**PERRY NUCLEAR POWER PLANT**

May 17, 1993  
PY-CEI/OIE-0404 L

Perry Nuclear Power Plant  
Docket No. 50-440  
Response to Confirmatory Action Letter

BACK FLUSH OF RHR "A" (B) STRAINER

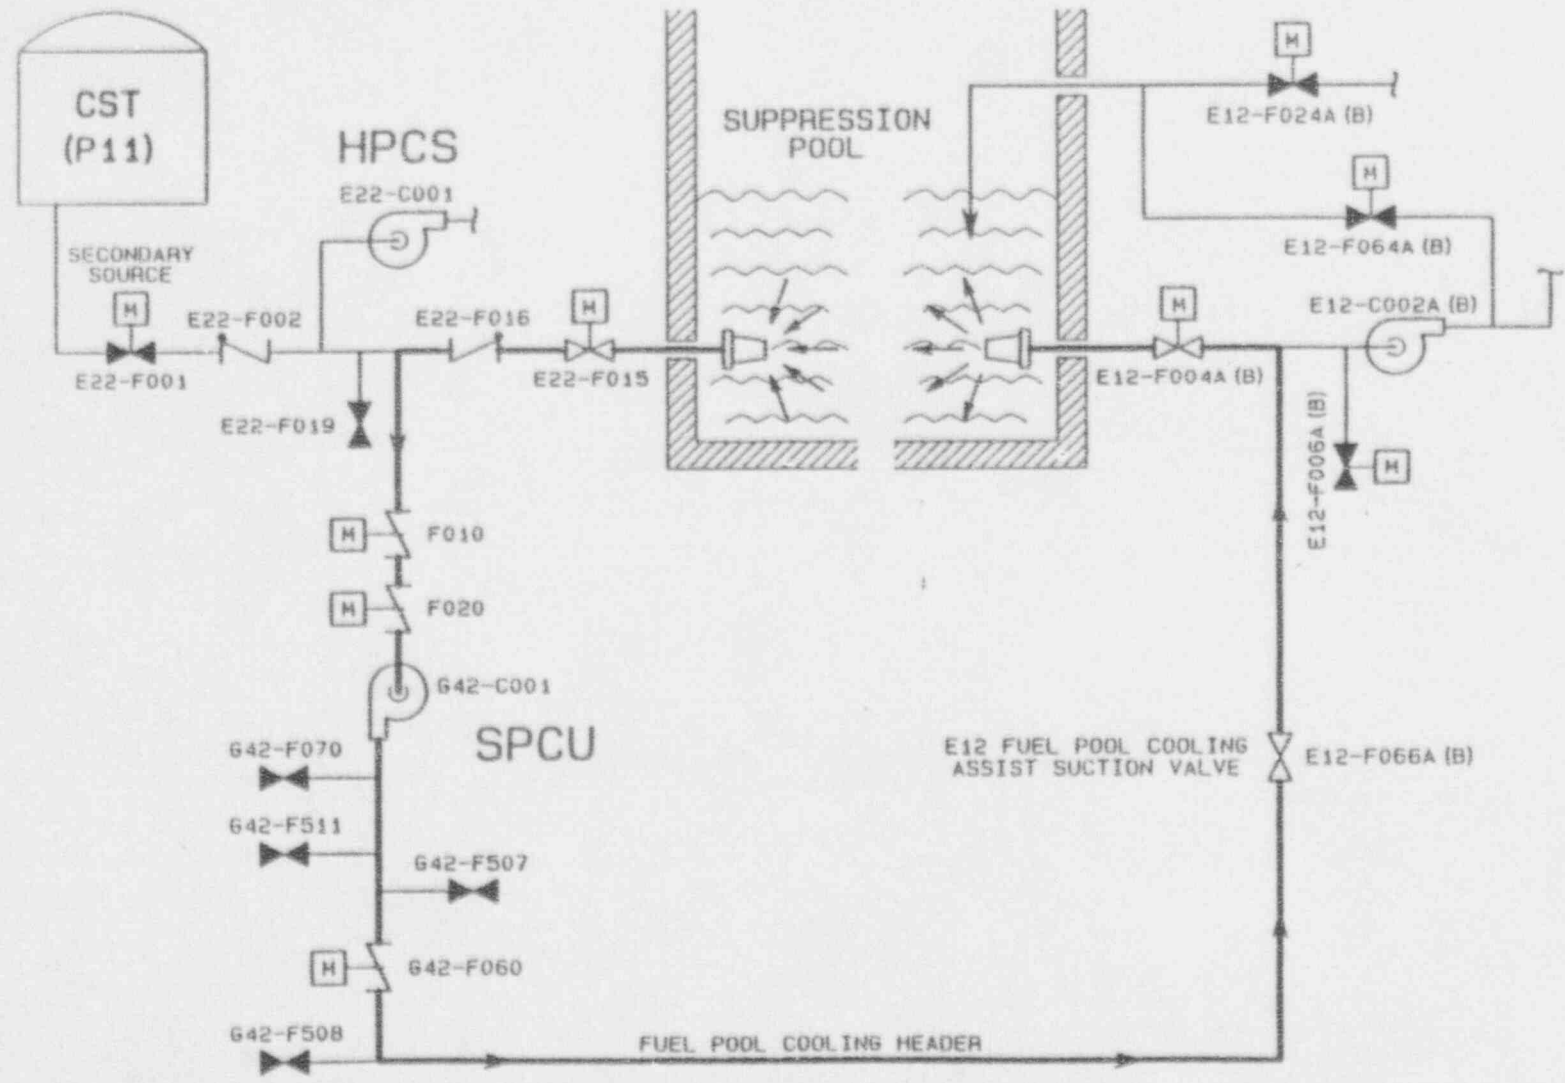
4. Question: Please provide a one-line diagram of a suction path for backflushing RHR suppression pool suction strainers.  
Response: See Figure below.
